PERMIT

SEWAGE DISPOSAL SYSTEM

SUBDIVISION _____ ROAD 14064 Forsythe Road LOT _____

REPAIR - REPLACE METAL SEPTIC TANK WITH A CONCRETE TANK.

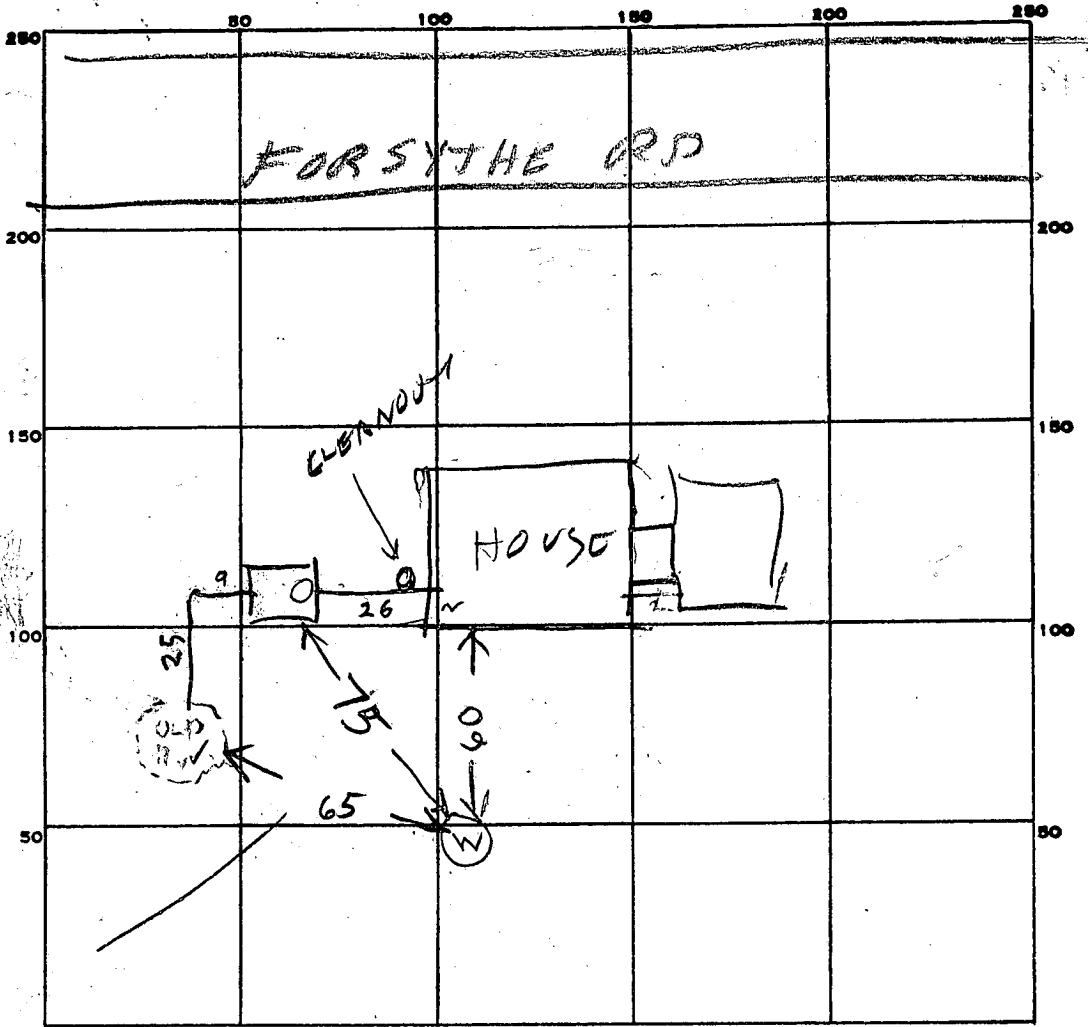
REMARKS 3/22/85 - TANK OK DW A LITTLE
TOO CLOSE TO WELL (MEASURED
WITH A TAPE)
